Access Compliance Report

Public Rights-of-Way

(Curb Ramps)

Intersection ID: 54219	Main Street: SANDY_ROCK_PL	Cross Street: NORTH_REA_PARK_LN	Location: NE
ADA ID: F99E41113333	Ramp Type: Perp	Initial Pass/Fail: Fail	Overall Compliance: No
Severity Score: 12.5			
Codes/Mitigation Info/Possible Solution		Field Measurements/Component Compliance

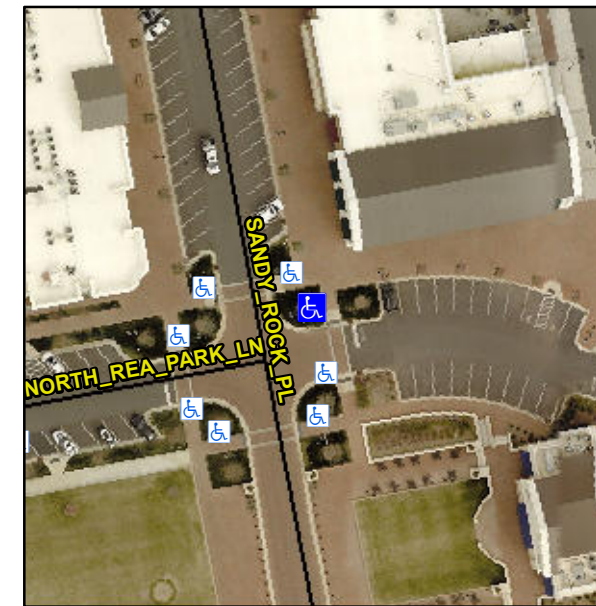
Compliance	Description	Data	Compliance	Description	Data
N/A	Ramp Length (in)	91.0	No	Ramp Slope (%)	10.3
Yes	Ramp Width (in)	91.0	Yes	Ramp XSlope (%)	0.9
N/A	Flare Type LT	N/A	N/A	Flare Type RT	N/A
N/A	Flare Slope LT (%)	N/A	N/A	Flare Slope RT (%)	N/A
N/A	Flare Traversable LT?	N/A	N/A	Flare Traversable RT?	N/A
N/A	Landing Length (in)	N/A	N/A	DWS Provided?	N/A
N/A	Landing Width (in)	N/A	N/A	DWS Contrast?	N/A
N/A	Landing Slope (%)	N/A	N/A	DWS Length (in)	N/A
N/A	Landing X Slope (%)	N/A	N/A	DWS Full Width?	N/A
N/A	Landing Curb? (Y/N)	N/A	N/A	DWS Offset (in)	N/A
N/A	Shared Landing?	N/A			
N/A	Gutter Ponding?	N/A	N/A	Gutter Slope (%)	N/A
N/A	Gutter Lip Ht (in)	N/A	N/A	Gutter X Slope (%)	N/A
N/A	Painted X Walk1?	Yes	N/A	Painted X Walk2?	N/A
	X Walk 1 Direction	To S		X Walk 2 Direction	N/A
N/A	X Walk 1 Width (in)	78.0	N/A	X Walk 2 Width (in)	N/A
	X Walk 1 Slope (%)	0.7		X Walk 2 Slope (%)	N/A
	X Walk 1 X Slope (%)	0.6		X Walk 2 X Slope (%)	N/A

Remove & Replace Entire Ramp.
